TO: Plan Commission
FROM: Kevin Briski, Parks Superintendent
DATE: October 29, 2013
SUBJECT: Birchwood Point

SHEET TITLE:
SITE PLAN

PROJECT:
BIRCHWOOD POINT PLAT

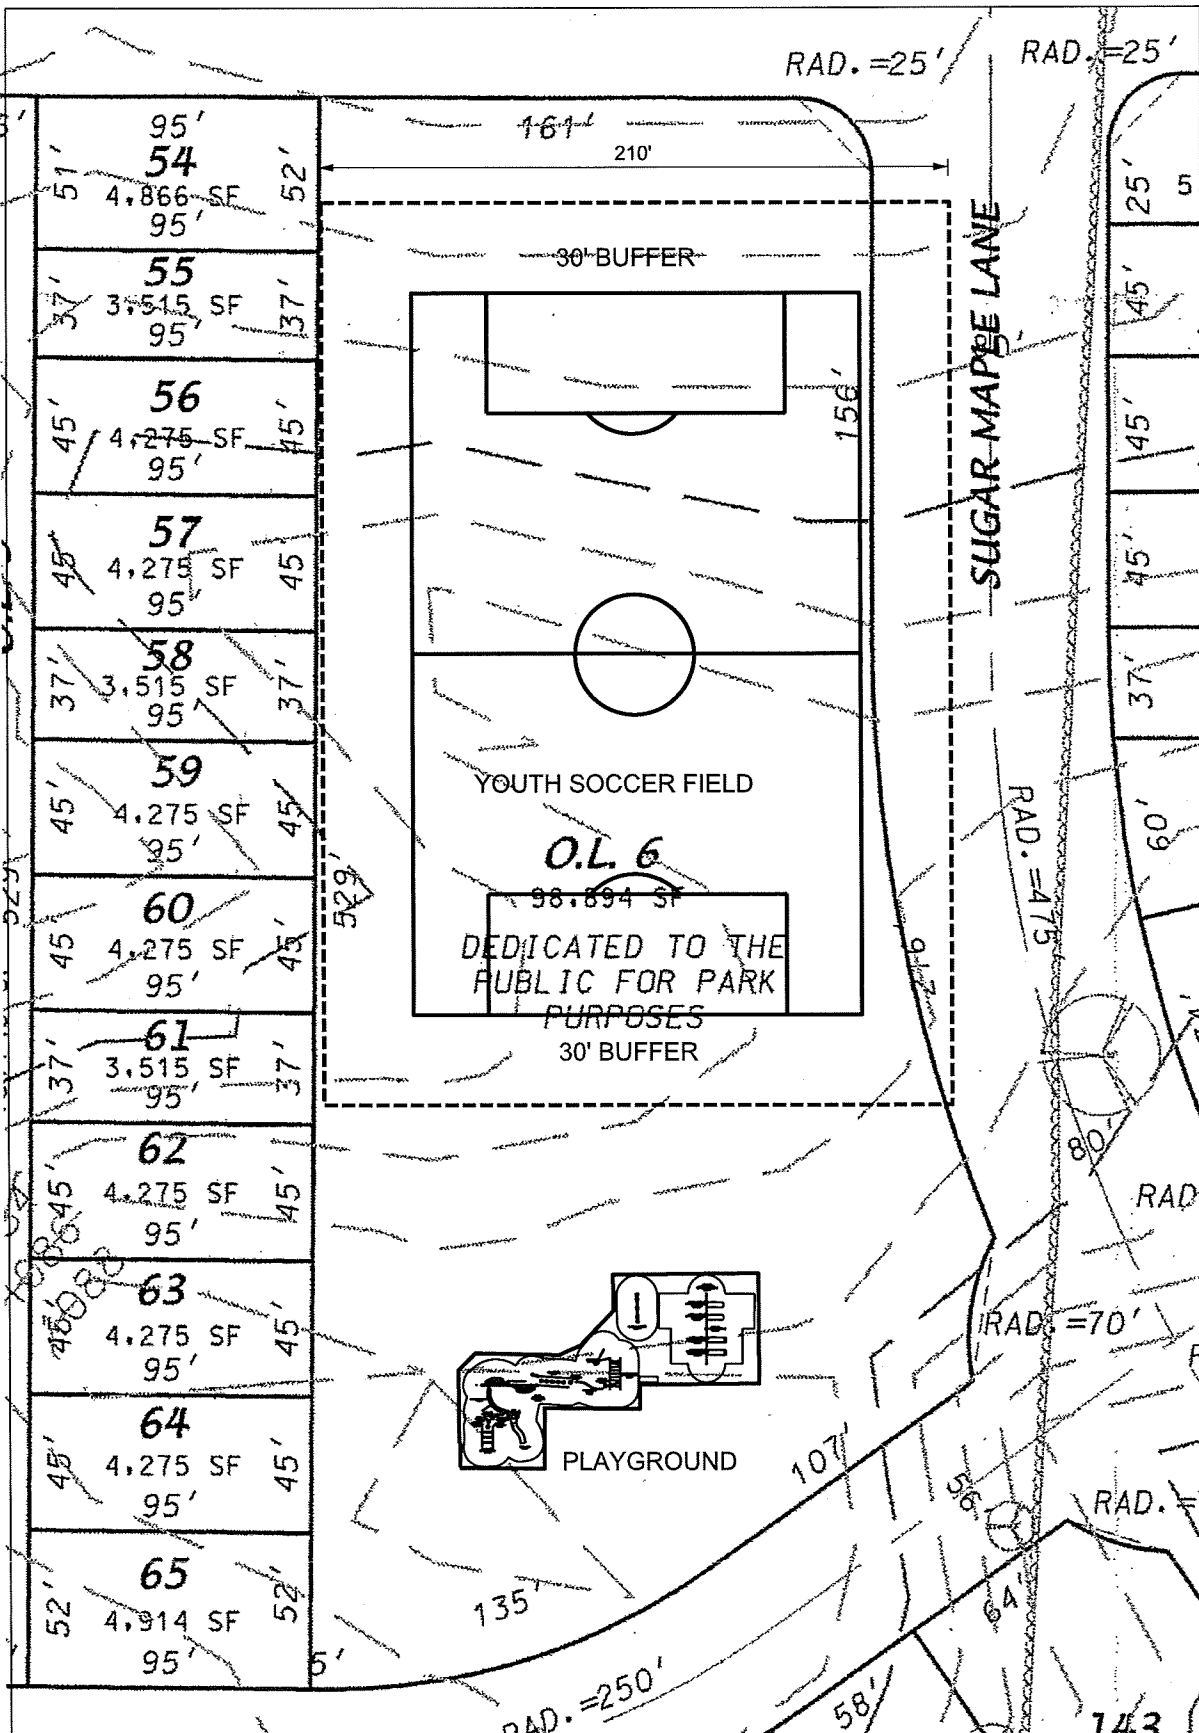
Outlot 6 as currently configured will not allow the Parks Division to develop public recreational amenities consistent with the adopted Park and Open Space Plan for a neighborhood park. The east-west dimension of Outlot 6 is not adequate to provide space for an open play field that can be used for youth-size soccer (see attached). The Parks Division is willing to accept Outlot 6 as public parkland if the east-west dimension is not less than 210 feet as shown on the attached exhibit. This distance cannot be encumbered with public sidewalks or any other hardscape; if public sidewalks are included with the parkland dedication, then the area to be dedicated should be increased to retain the dimension in unencumbered space identified above. No underground utility easements shall be located along the park perimeter unless approved by the Parks Division.
